# SPARTAN CHASSIS, INC.

TSB07-210-001A

## TECHNICAL SERVICE BULLETIN

**SUBJECT:** Frame - Cab Mounting

FIG. 2-1

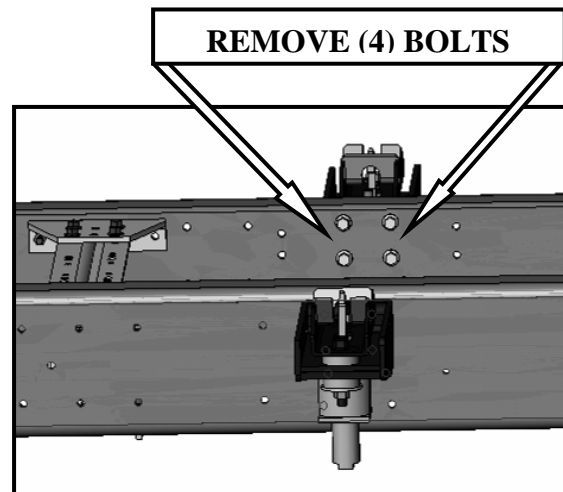
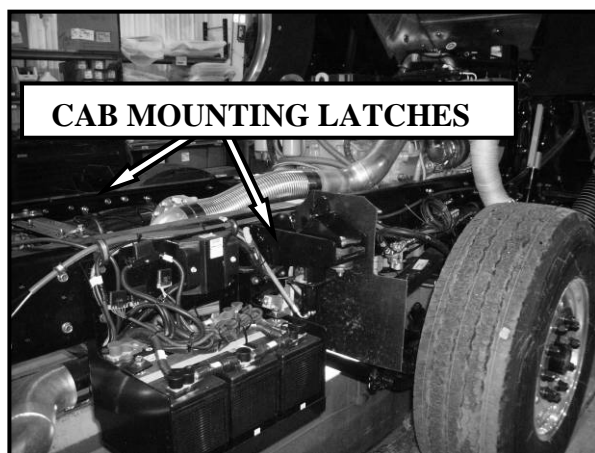
**CONDITION:** Cab mount to frame fasteners may break.

1. Observe all industry safety standards and secure vehicle for removal and installation of cab mount isolated latch.
2. Tilt cab and insure safety bracket is engaged.
3. Refer to FIG. 2-1. Locate and remove cab mount isolated latch assembly. Save latch assembly and spacer (if present) for reuse; properly discard fasteners.
4. Enlarge the four (4) mounting holes to 19/32" or .594 on the latch assembly and spacer (if present).

5. Enlarge the four (4) latch mounting holes to 19/32" or .594 on the frame rail.
6. Reinstall the assembly and spacer (if present) using the fasteners supplied in the kit. Insure the spacer is between the assembly and frame rail. Torque to 95 ft. lbs.

*NOTE: Fasteners must be installed from the inside of frame-rail to the outside of frame-rail.*
